New Albany Planning Commission Meeting Agenda
Monday, June 17, 2024 at 7:00 p.m.

**PANDA EXPRESS
FINAL DEVELOPMENT PLAN**

LOCATION: Located generally at the southeast corner of Smith’s Mill Road and Johnstown Road (US-62) (PID: 222-005377)
APPLICANT: Panda Restaurant Group, c/o Josh Hibbits
REQUEST: Final Development Plan
ZONING: Infill Planned Unit Development (I-PUD): Canini Trust Corp, subarea 8a
STRATEGIC PLAN: Retail
APPLICATION: FDP-22-2024

Proposed Site Plan

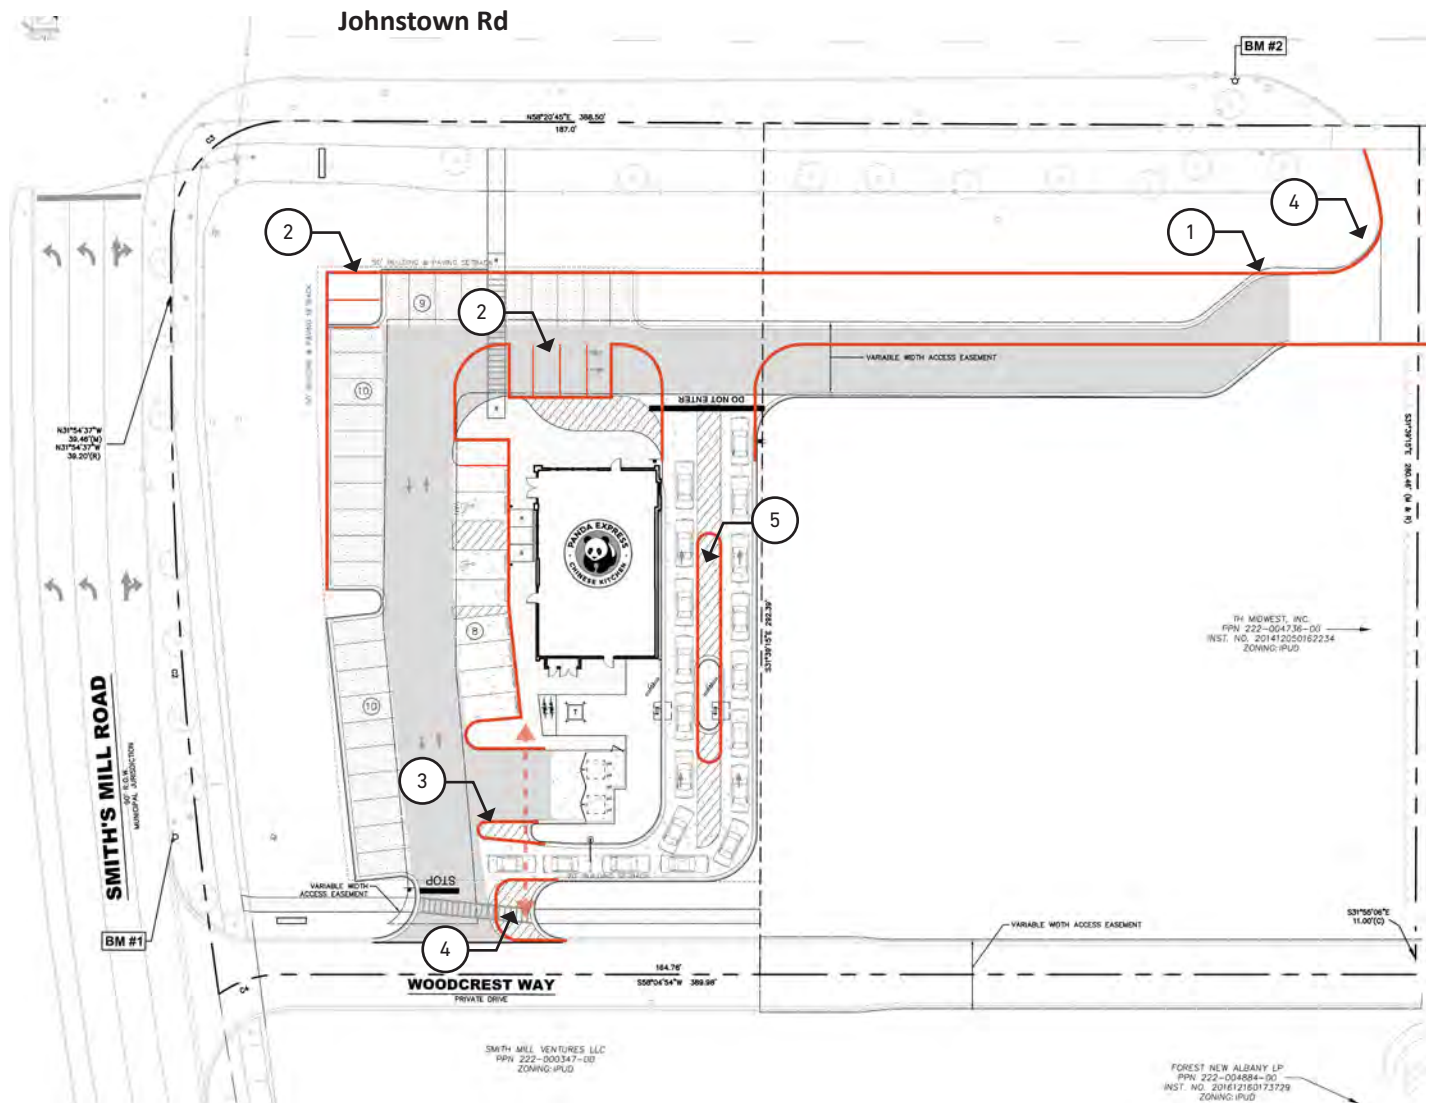
1. Realign the access drive adjacent Johnstown Road to create a consistent transition from the existing drive at the neighboring parcel. See diagram.
2. Realign the proposed parking to follow the building and pavement setback with the shifted access drive, and accommodate minimum parking requirements. See diagram.
3. Reevaluate curb alignment at drive-through entrance. Minimize pavement and striping conditions where possible. See diagram.
4. Consider a safe pedestrian connection into the site from the proposed sidewalk along Woodcrest Way. Recommend considering a future pedestrian connection from the drive at Johnstown Road to connect with the adjacent parcel.
5. Extend the drive-through lane median to reduce pavement and extend landscape planting zone. See diagram.

Proposed Planting Plan

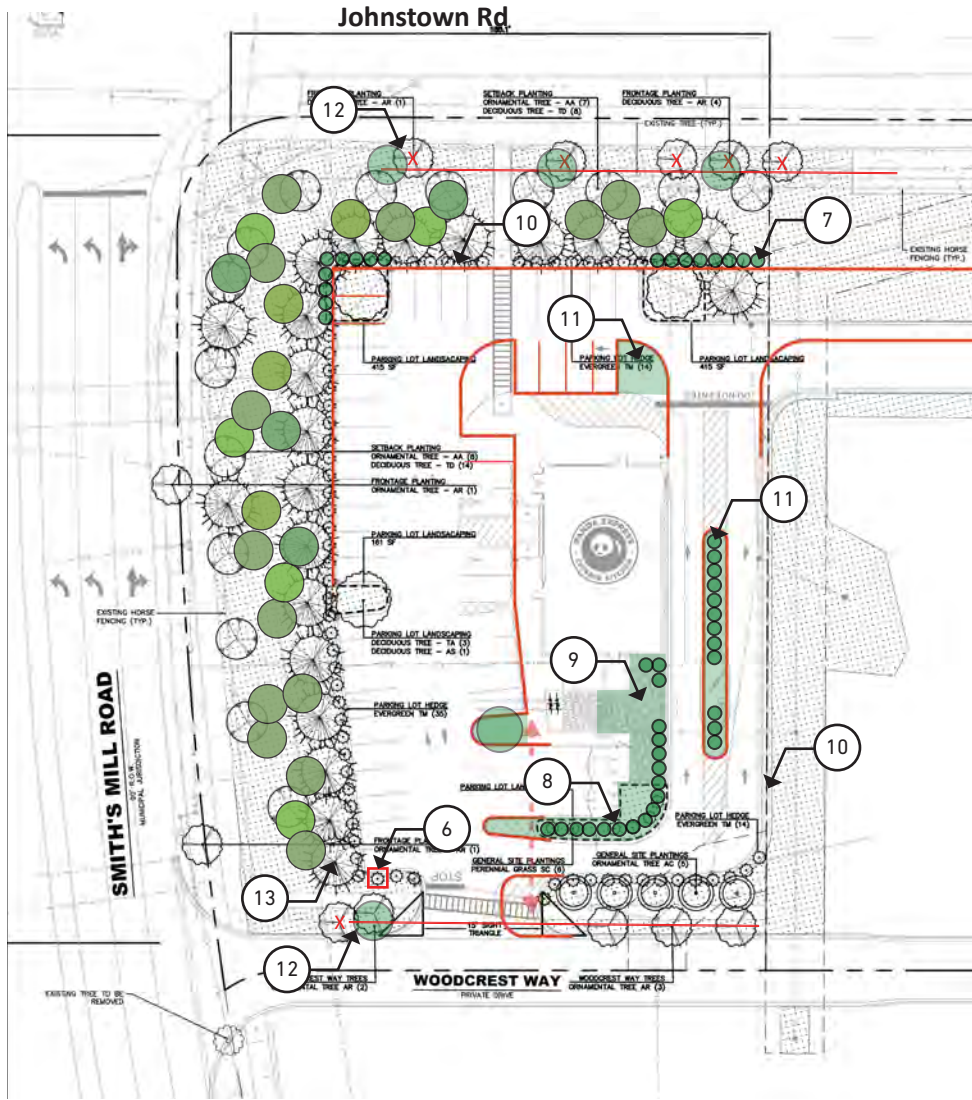
- Update the planting legend and labels to properly reflect proposed plan material. Current plan symbols misrepresent deciduous shrubs along parking lot to be perennial grass.

- Extend use of evergreen shrub, 36" in height, to screen drive-through.
 - Increase density of perennial grass at drive-through entrance.
 - Remove the use of rock beds along the drive-through and extend plant bed and material along the drive-through lanes to match existing condition present in other sites within New Albany.

- Remove use of rock beds at edge of pavements and replace with lawn or mulched planting beds where applicable.
 - Include planting in proposed curb extensions.

- Realign trees along Johnstown Road and Woodcrest Way as marked. Placement to be evenly spaces and aligned along both sections.
 - Replace use of Bald Cypress (*Taxodium Distichum*) along the parking lot with a deciduous shade tree. Recommend use of one of the following: *Liriodendron tulipifera*, *Nyssa sylvatica*, *Platanus x. acerfolia*, *Gymnocladus dioicus*. Tree placement should adhere to tree grouping standards.

August 2023 (Figure 1)

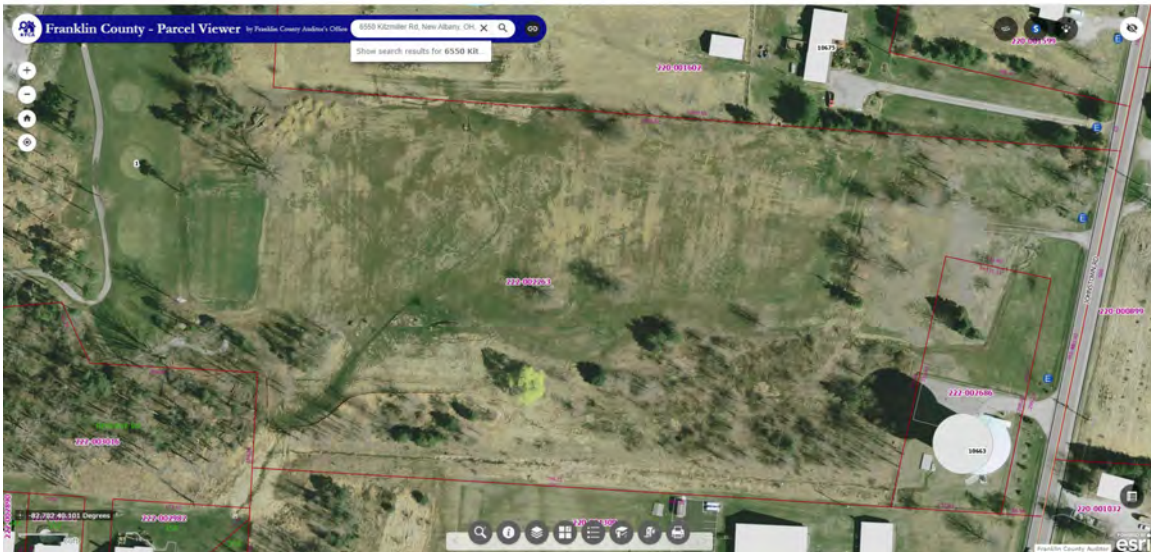
The images below show the existing conditions when the final development plan was approved in 2009 (Figure 2) and current 2023/2024 conditions (Figure 1).

Planting Plan

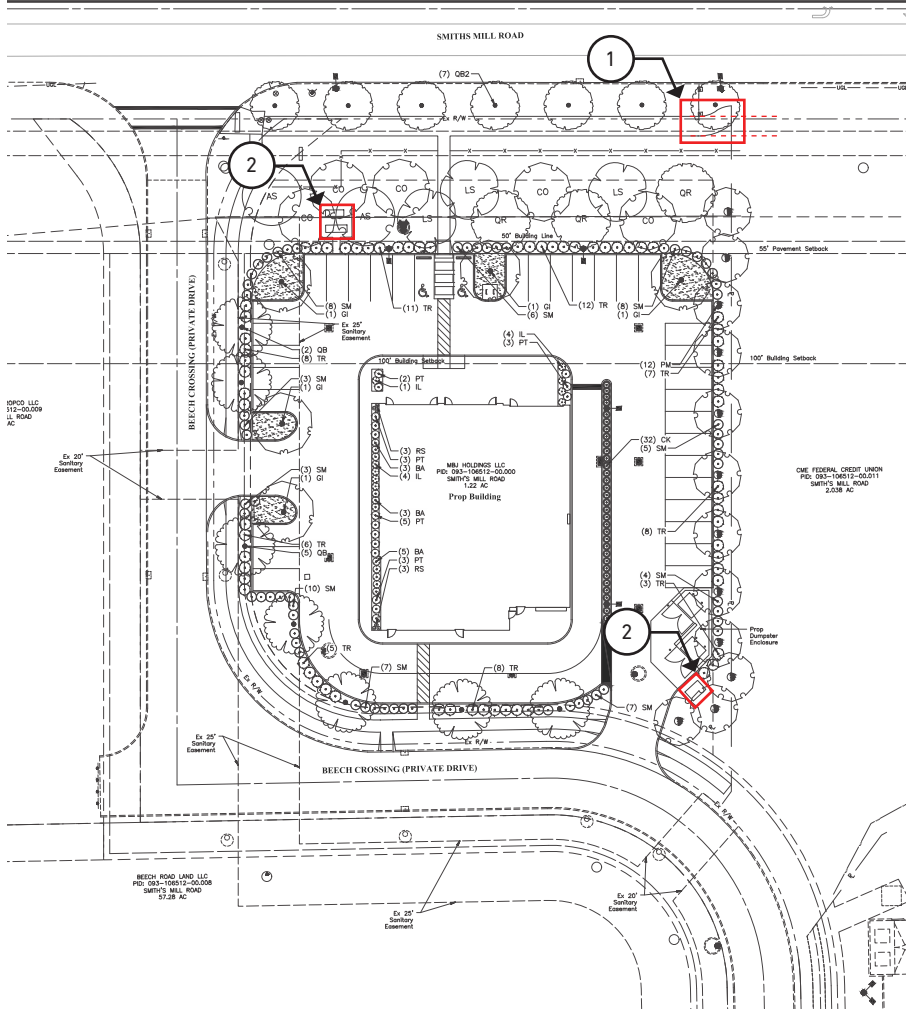
2. Provide evergreen shrubs (36" in ht.) to screen utilities, as marked. See diagram.

Proposed Site Plan

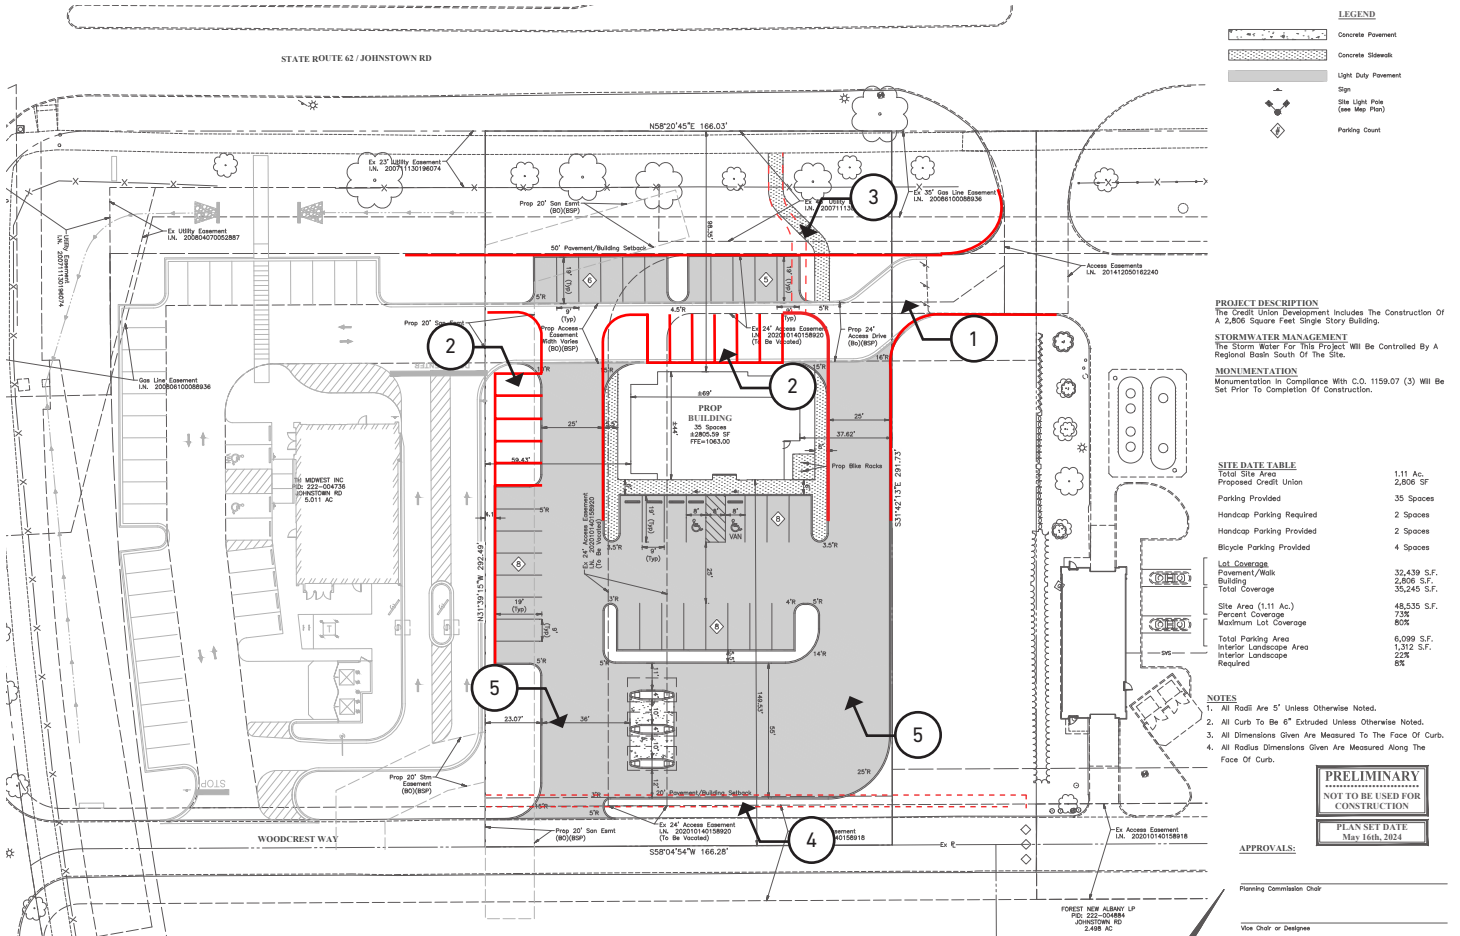
3. Expand the view port on the cover sheet to show the existing regional basin that will be utilized for stormwater management.
4. A 6 inch sanitary sewer is shown as "By Others" on sheet 2. Note that mainline sanitary sewers must be a minimum of 8 inches per the COC/DOSD Design Manual.
